PLANNING AND DEVELOPMENT SERVICES STAFF REPORT

For Planning Commission Meeting of December 02, 2014

**SUBJECT: 2250 Ann Arbor-Saline Road Zoning and Site Plan for City Council Approval
(2250 Ann Arbor-Saline Road)
File Nos. A14-003, Z14-017 & SP14-023**

2250 ANN ARBOR-SALINE ROAD
 SITE PLAN
 DIMENSIONAL SITE PLAN

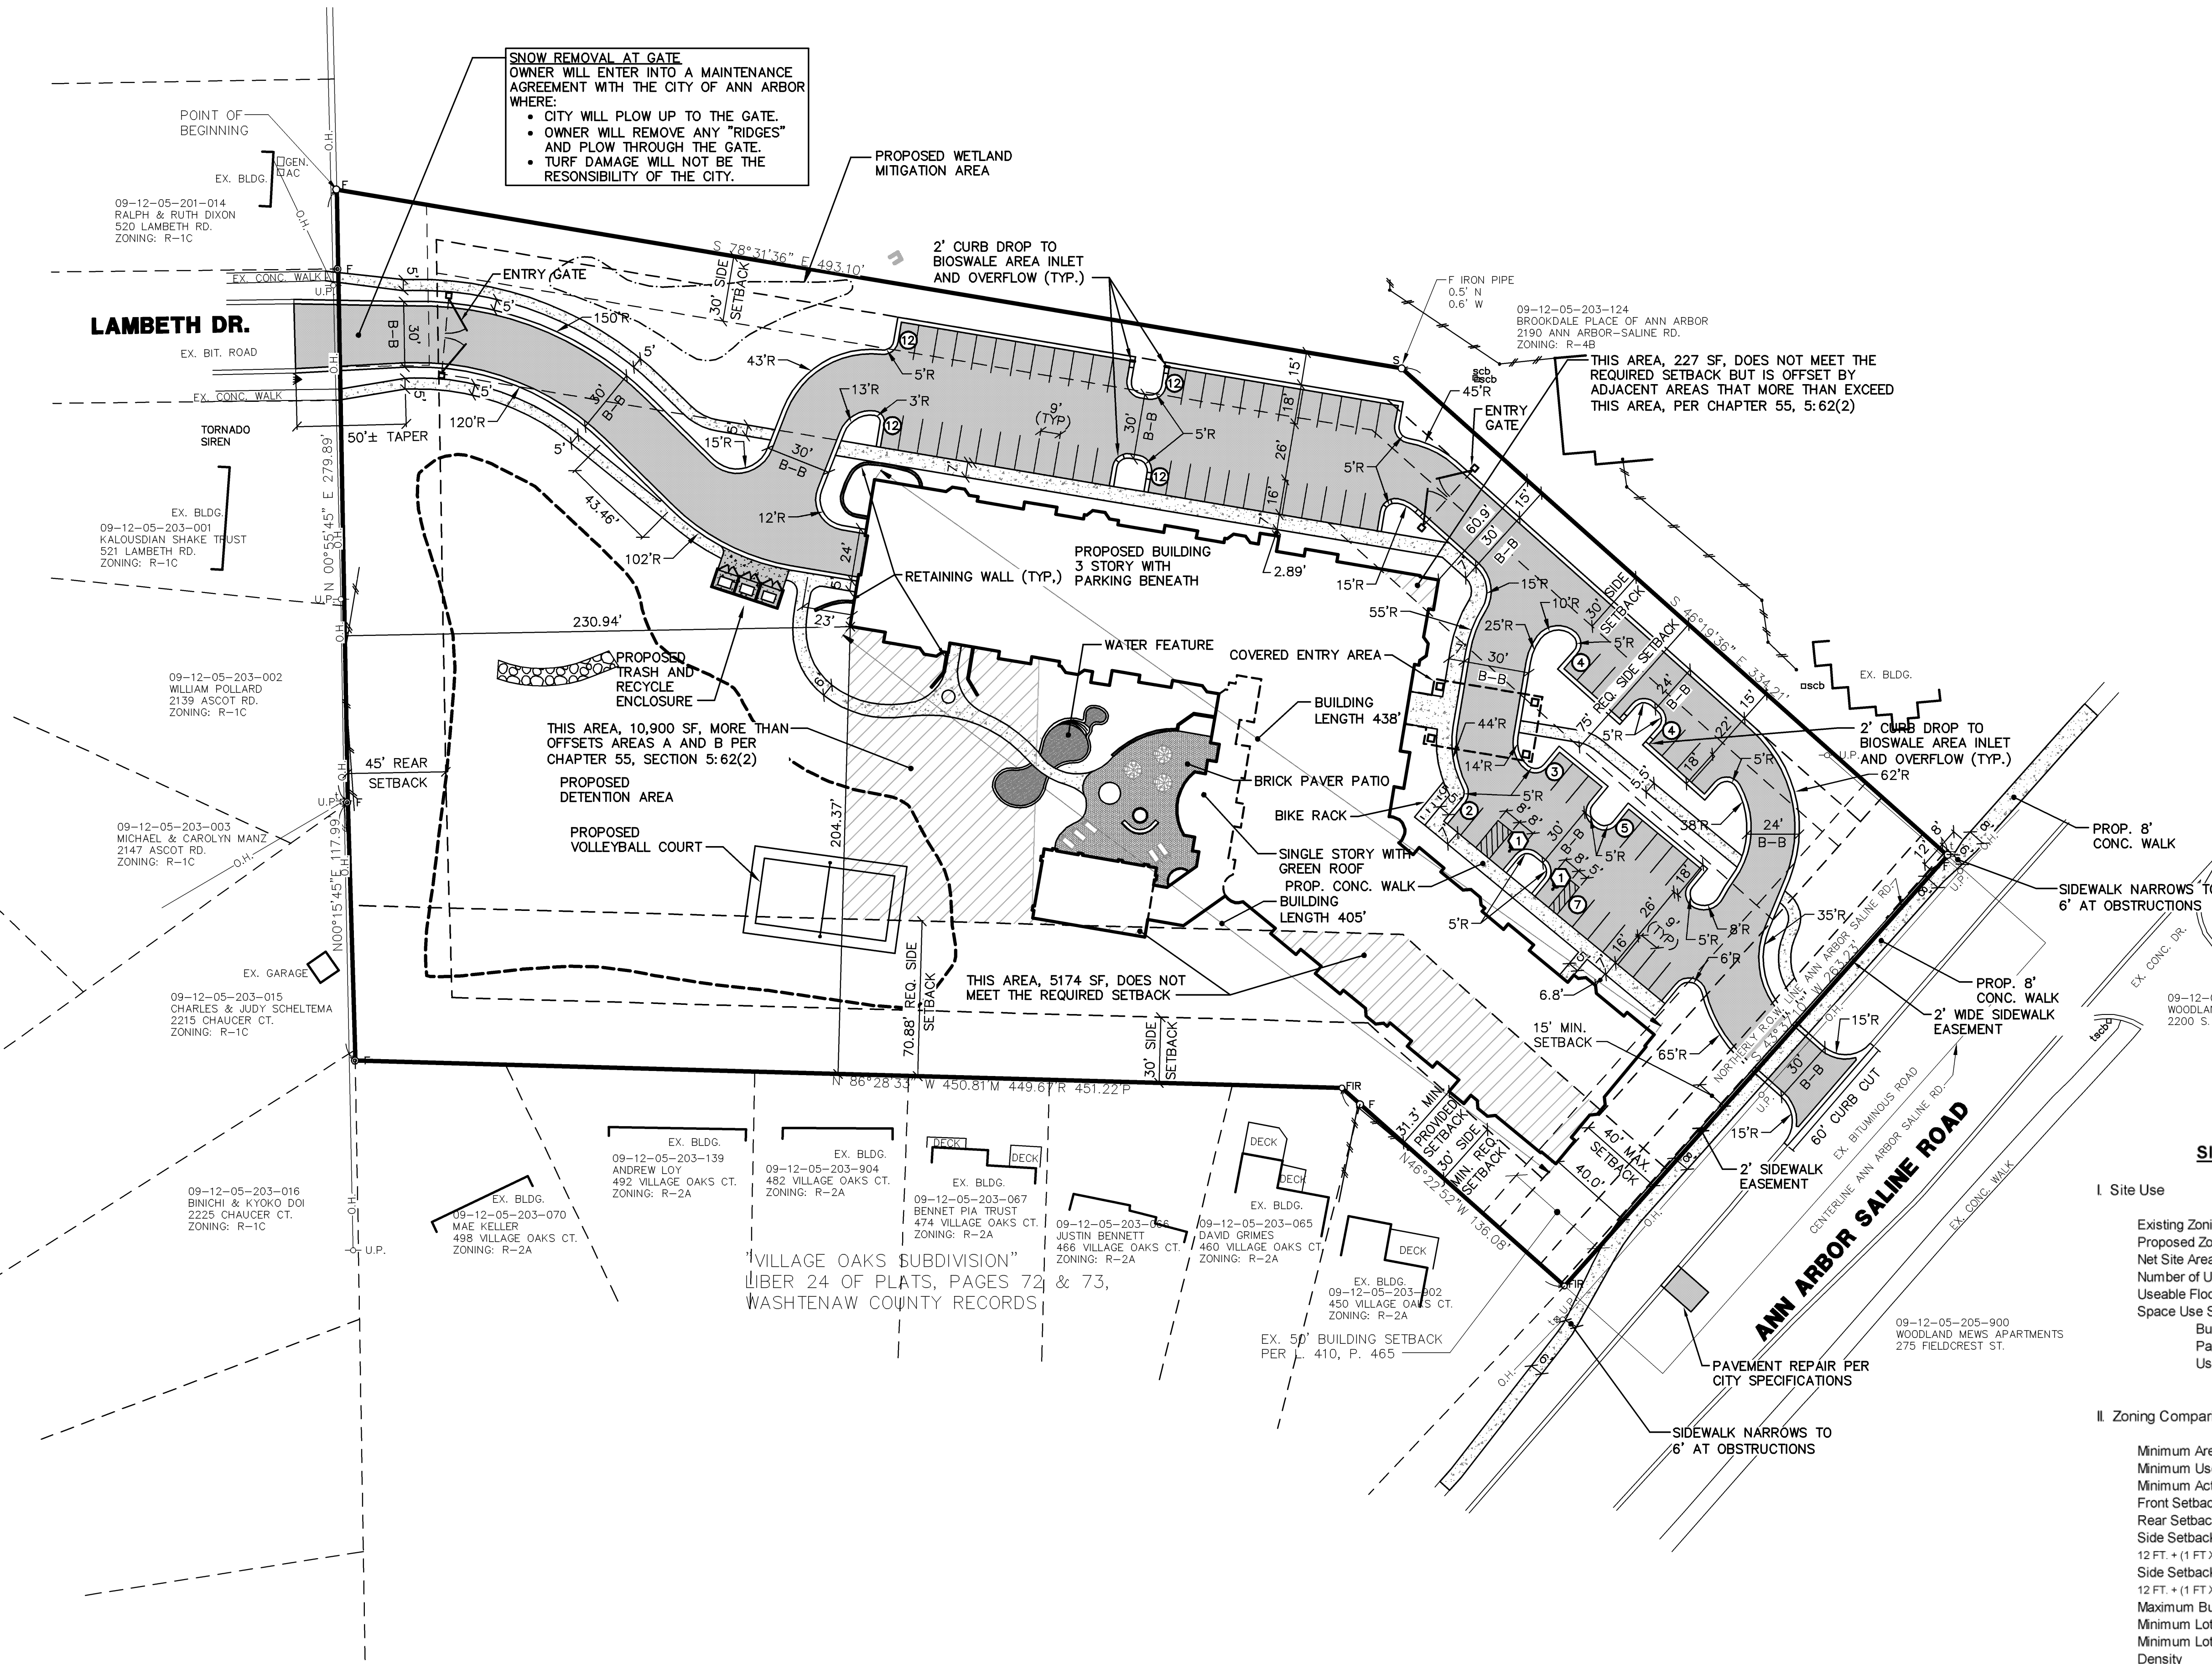
The site plan as submitted does not have general purpose connection to Lambeth, only a gated emergency and resident access point. Traffic Engineering staff supports a general purpose connection as it would benefit the public providing for improved neighborhood connectivity, a

Parks – Petitioner has provided some outdoor amenities, however the location of the volleyball court is not supported by Parks staff. Staff has suggested providing outdoor exercise equipment (instead of the volleyball court) to compliment the interior gym. If this provided, Parks staff may be able to reduce or waive the requested parks contribution. If there are no exterior amenities provided for residents, the requested donation will be \$46,500.
